# STAFF RECOMMENDATION

K. Walton  
NCPC File No. 6331

## THE SMITHSONIAN INSTITUTION NATIONAL MUSEUM OF AFRICAN AMERICAN HISTORY AND CULTURE

March 31, 2011

Service Access Studies

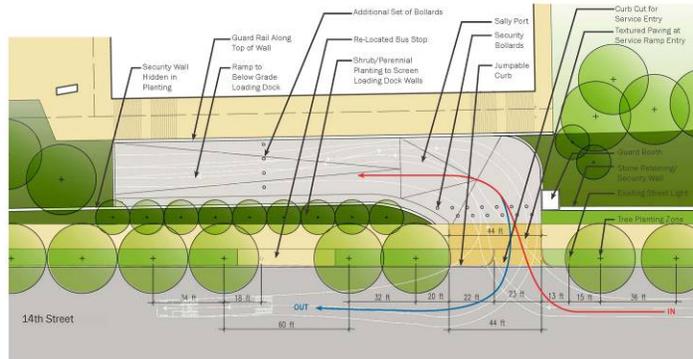
The museum site presented service access challenges because all sides front onto important streets. The Smithsonian selected 14<sup>th</sup> Street as the service entry point because it has the least impact of the alternatives. The District of Columbia Department of Transportation (DDOT) and the District of Columbia Office of Planning (DCOP) raised questions about the location due to high traffic volumes at peak hours, and the streets gateway prominence. In response to these concerns the Smithsonian improved the sites access along 14th street to allow for more green space to soften the truck entrance. This change was done in consultation with NCPC staff, DDOT, DCOP, National Park Service (NPS) and other federal partners. Adjustments were made on site to allow for security screening to accommodate a 73' truck and allow for the proper truck

turning radius from 14th street. It was determined that a covenant could be provided to ensure that the large 73' tractor trailer truck deliveries occur between 11:00 pm and 6:30 am to minimize traffic interruptions during daytime hours. Other considerations discussed noted that keeping the service access on site would allow the museum construction activity to be limited to the NMAAHC site The Smithsonian will continue to work with DDOT as project proceeds.

### Site Massing and Skylight Development

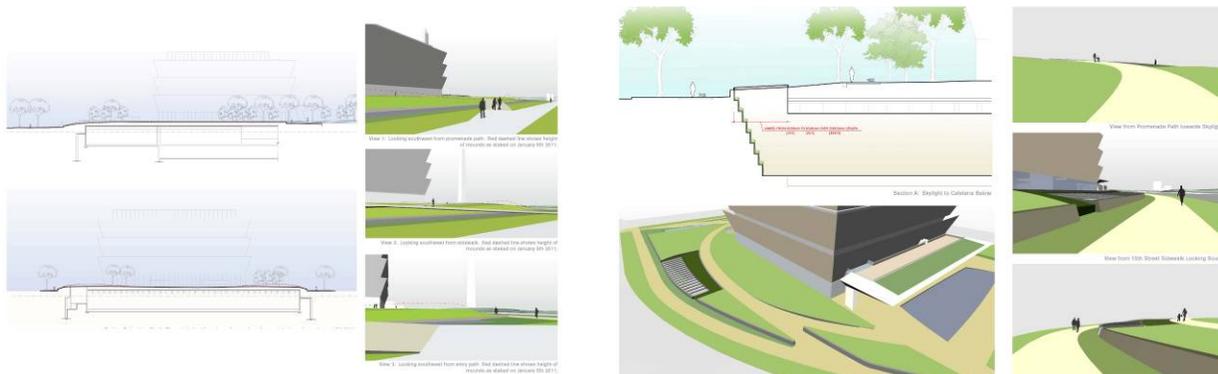
The design at the September concept presentation did not show a location for the skylight elements required for the lower level gallery spaces. It was also indicated that the building yard on the north side of the site between Constitution Avenue and the building face should continue to read as landscape rather than building. A large earthberm (knoll) had been planned on the north side to cover a portion of the lower level gallery space that will house very large permanent exhibits.

The Smithsonian has responded by reducing the profile of the subsurface concrete construction and soil overlay to remove the high knolls from either side of the north entrance to the museum. These steps resulted in developing a more fluid low profile landscape both at the north entrance, and around the west side of the site to reflect the rolling landscape of the Washington Monument Grounds. The designers also added a lower profile set of skylights on the west side (15<sup>th</sup> Street) of the site as recommended by the Commission of Fine Arts. These elements represent a reduction in the overall impact of skylight glazing, but their scale still requires further study.

### Building Massing Development

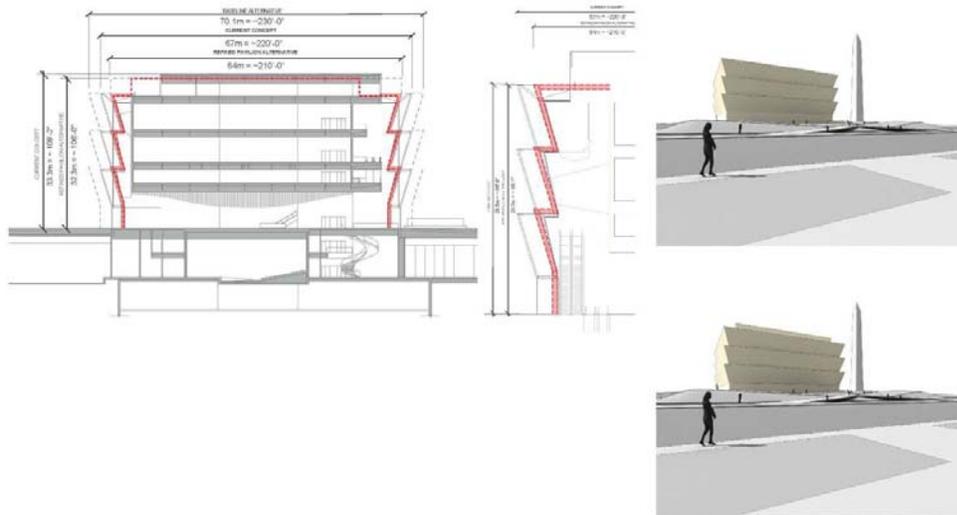
The Smithsonian has also developed a skin concept, a pierced metal façade for the Corona with viewports and glazing for outward views to major monuments and site features. These design elements add a great deal to the museums character. The structural armature for the Corona skin however has added an additional five feet to the mass of to each side of the building.

While this does not impact key views, the overall reduction of the building mass which was noted as being commendable at the concept presentation has been increased, and the design team should continue to study options that reduce the buildings overall mass.

#### Slurry Wall Cross Section

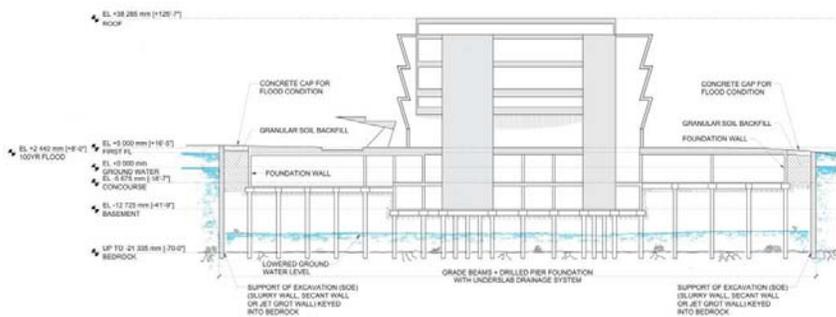
The Smithsonian was asked to continue analyzing the geotechnical conditions at the project site. Geotechnical studies have been continued with the consolidation of available information and planning for extensive testing beginning once the building perimeter is finalized. The use of slurry wall construction has been selected as having the least impact on dewatering of the site, which is the major contributor to adjacent property concerns. Site monitoring will be carried out throughout the construction process to assure the protection of adjacent foundations.

Security Plan

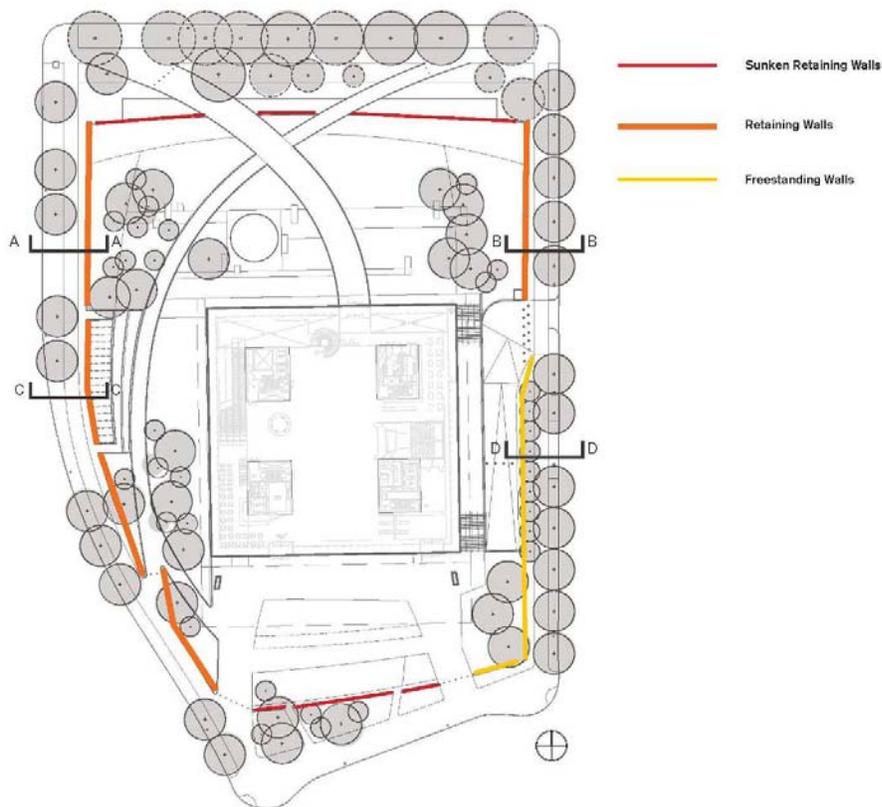
The design team eliminated bollards except where necessary, while more seamlessly integrating perimeter security walls, and site furnishings. The request at concept was that security elements should be integrated into the landscape to the extent possible in order to reduce visual impacts on the adjacent environment.

A combination of bollards and retaining walls, capable of resisting the impact of the design basis vehicle threat, are to be installed along the site perimeter to meet the security requirements of the project. This secure perimeter has been integrated with the site design as much as possible to minimize its effect on the pedestrian experience. Bollards will only be used at path entries and are being held back from the sidewalk edge to minimize the visual effect on the sidewalk. On the north and south edges of the site, security retaining walls are integrated with and hidden within planted areas so that the site appears open and welcoming to visitors at the main site entries. On the east and west edges of the site, security walls are integrated with the edge of the landform. These walls are pulled away from the sidewalks so that the sidewalks have planting on both sides of them. The loading dock entry is equipped with retractable hydraulic bollards along the sidewalk edge. Trucks will be screened within the loading dock itself. The west wall of the loading dock will be designed to be capable of resisting the impact of the specified threat.

Lighting Intent and Character

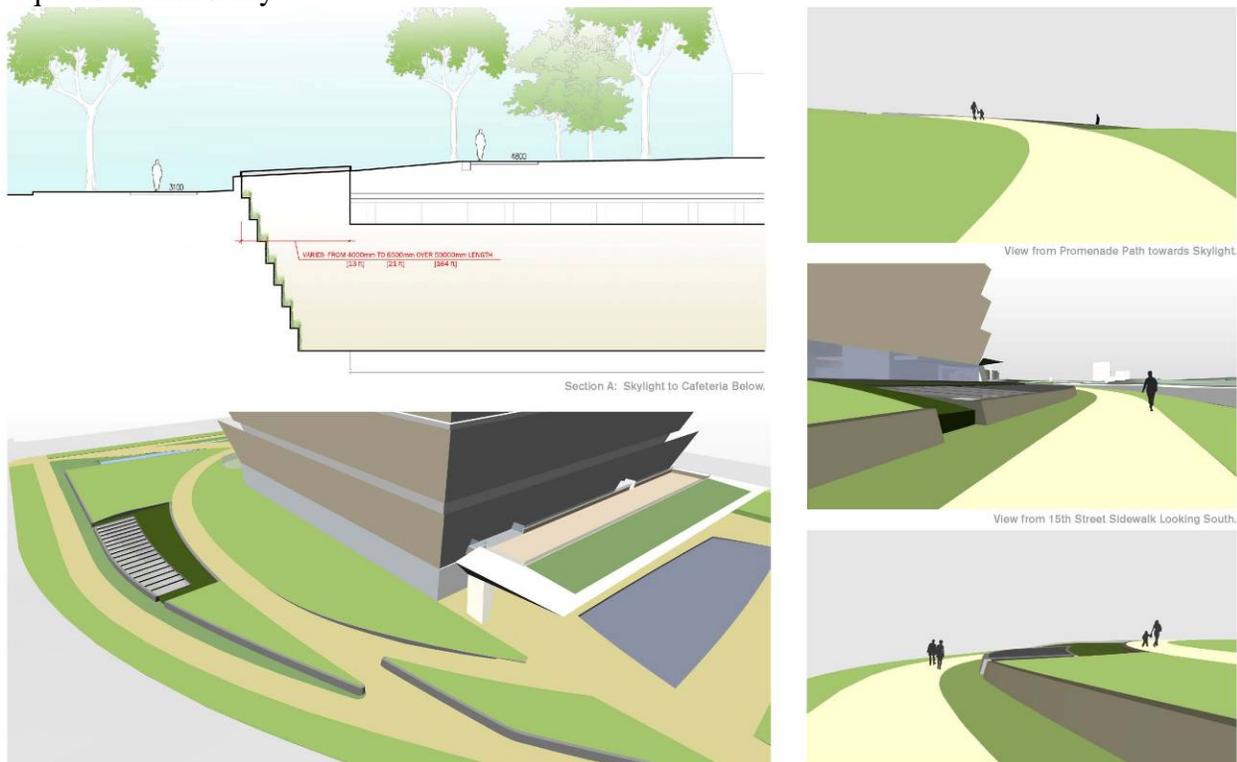
Staff also requested visual depiction of the building’s nighttime appearance and site lighting to indicate the intent and character of the project light enhancements. Night lighting has been indicated as a subdued palette. An initial rendering give a preliminary indication of the building’s appearance during evening hours, but until the glazing and skin are more refined, it is an area of study which the Smithsonian’s design team will continue.

## Courtyard- Egress

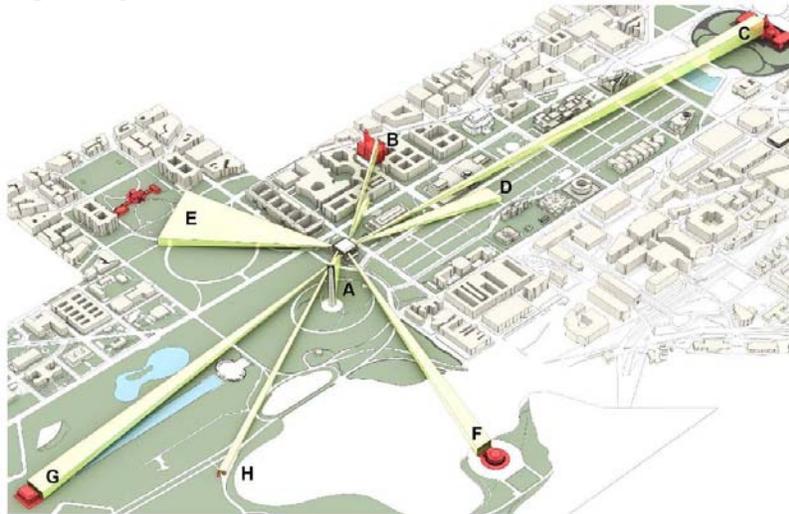
In between the loading dock and the building there is an egress courtyard that is central to the egress strategy of the building. The courtyard provides the egress needed for the levels below grade through this one space. Therefore, building egress elements like staircases are kept out of other areas of the landscape. The courtyard also allows light to get to the mezzanine level of the building.
